Docket No. 50-346
License No. NPF-3
Serial No. 1-179
January 5, 1981

This letter is in response to IE Bulletin 80-24 dated November 21, 1980, (Log 1-446) as applicable to Davis-Besse Nuclear Power Station. Attached is Toledo Edison's required 45-Day response to the items of the Bulletin.

SUBMITTAL
FOR THE
DAVIS-BESSE NUCLEAR POWER STATION
UNIT 1
FACILITY OPERATING LICENSE NPF-3
IN RESPONSE TO A CFR 50.54 (f)
REQUEST DATED NOVEMBER 21, 1980

FIGURE 1
Simplified Drawing of
Service Water to the Containment
Air Coolers

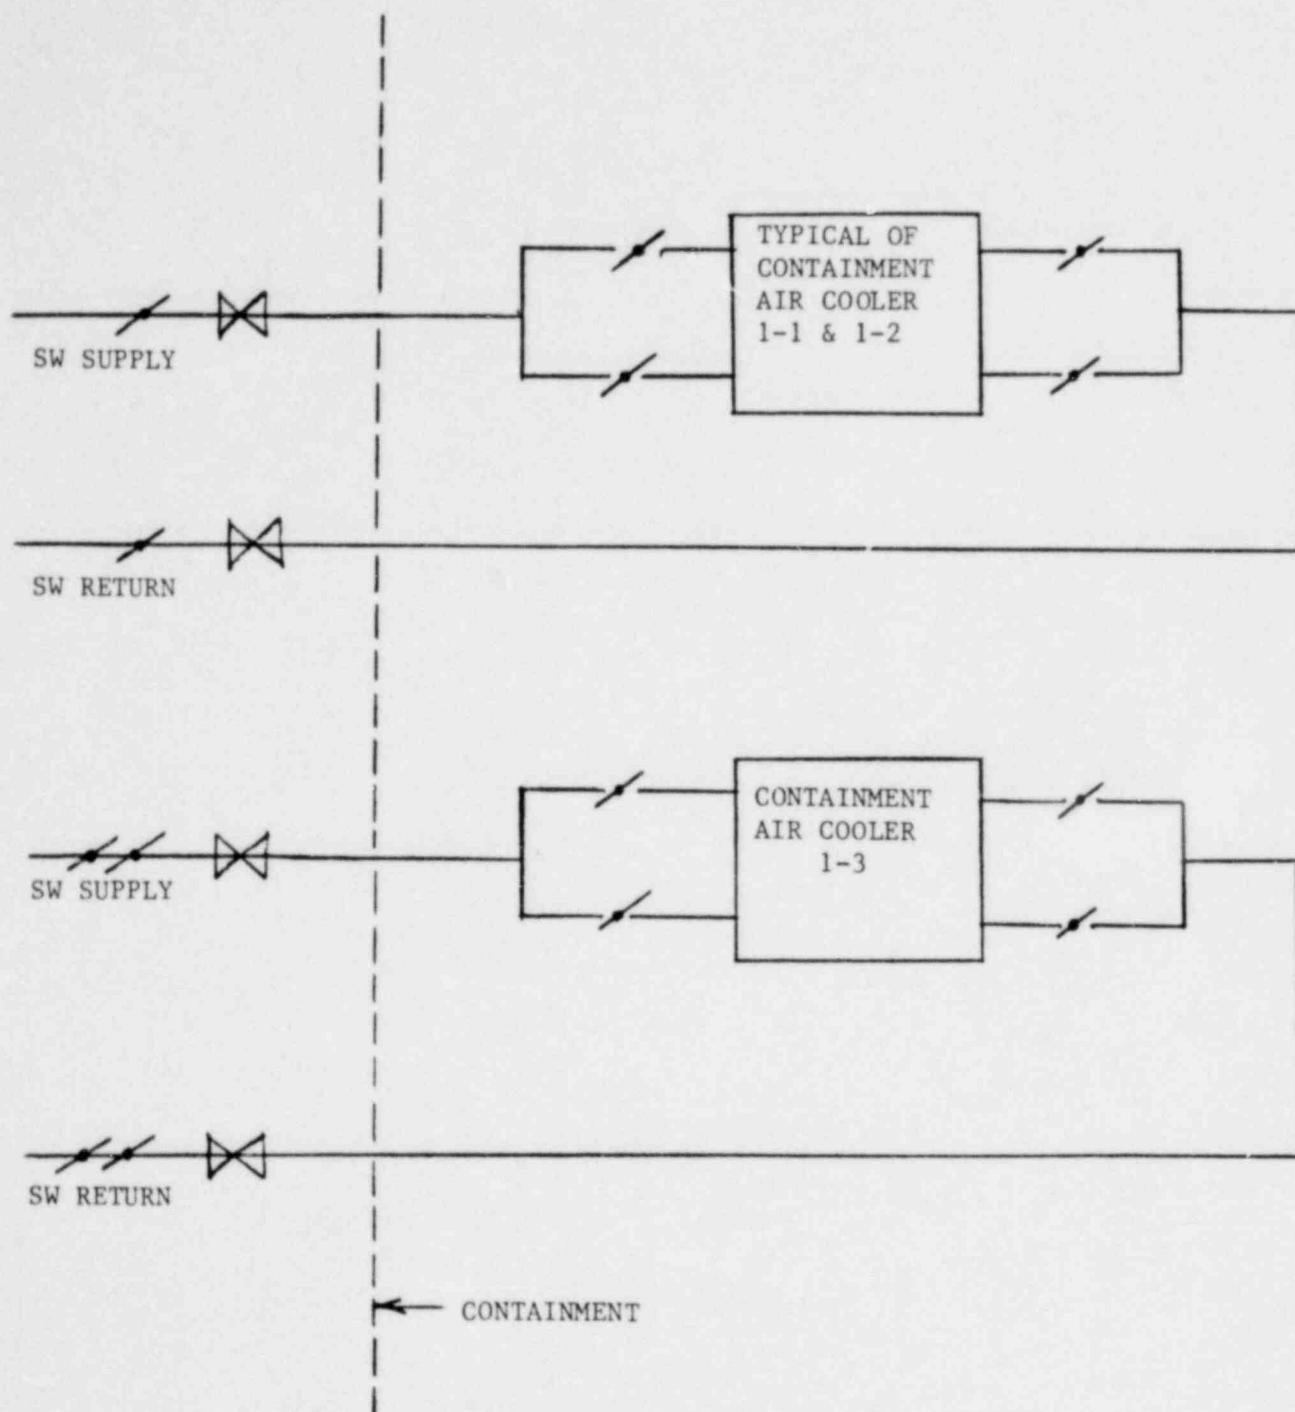
Item 1F.

Each Containment Air Cooler has a 8" Service Water supply header which enters containment and splits into two - 6" supply lines which supply the Containment Air Cooler with cooling water.

Each Containment Air Cooler has two 6" Service Water return lines which combine into one 8" return header, inside Containment, leaving Containment as a 8" header (see Figure 1).

In the event of a Service Water System leak inside containment, the Service Water System in containment may be isolated from outside and/or inside containment.

If a Service Water leak is suspected in either the Service Water piping or Containment Air Cooler, the Service Water supply and return to each Containment Air Cooler may be completely isolated by valves located outside of containment. Containment Air Cooler 1-1 has two valves in series, in both the 8" supply header and 8" return header, which can be closed to isolate Service Water to Containment Air Cooler 1-1. Containment Air Cooler 1-2, also has two valves in series, in both the 8" supply header and 8" return header, which can be closed to isolate Service Water to Containment Air Cooler 1-2. Containment Air Cooler 1-3 has three valves in series, in both the 8" supply header and 8" return header, which can be used to isolate Service Water to Containment Air Cooler 1-3.

If the Service Water leakage is observed to be from a Containment Air Cooler, each Containment Air Cooler has provisions to be isolated locally, inside containment. The two 6" Service Water supply lines and two 6" Service Water return lines each have an isolation valve which can be closed, from inside containment to isolate Service Water to the Containment Air Cooler.

Since the Service Water supply and return lines to each Containment Air Cooler have a minimum of two-valve isolation (outside of containment), a single valve failure should not prevent the isolation of Service Water to the affected component.
